Airworthiness Directives; Honeywell International Inc. Turboprop Engines (Type Certificate Previously Held by AlliedSignal Inc., Garrett Engine Division; Garrett Turbine Engine Company; and AiResearch Manufacturing Company of Arizona)

Correction

In rule document 2015-25606, appearing on pages 61091 through 61093 in the issue of Friday, October 9, 2015, make the following correction:

Airworthiness Directives; Honeywell International Inc. Turboprop Engines (Type Certificate Previously Held by AlliedSignal Inc., Garrett Engine Division; Garrett Turbine Engine Company; and AiResearch Manufacturing Company of Arizona)

Figure 1 to Paragraph (e)–Airplane Operating Procedures

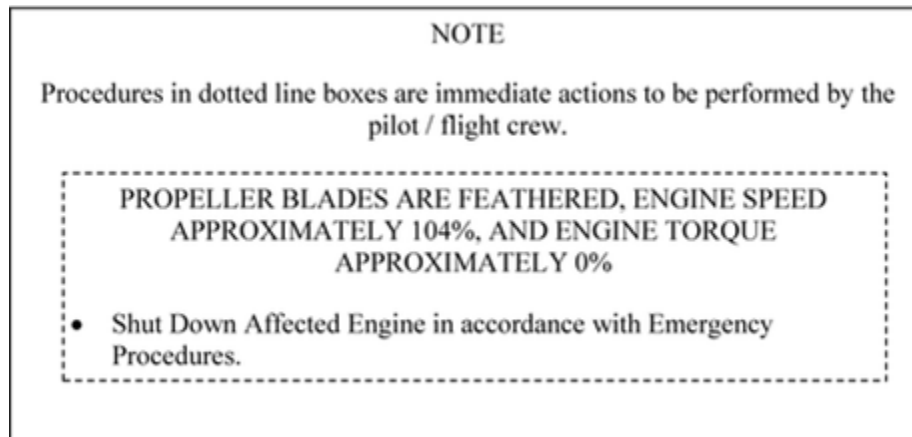
On page 61093, at the top of the page, the image heading "Figure 2 to Paragraph (e)–Airplane Operating Procedures" should read "Figure 1 to Paragraph (e)–Airplane Operating Procedures".
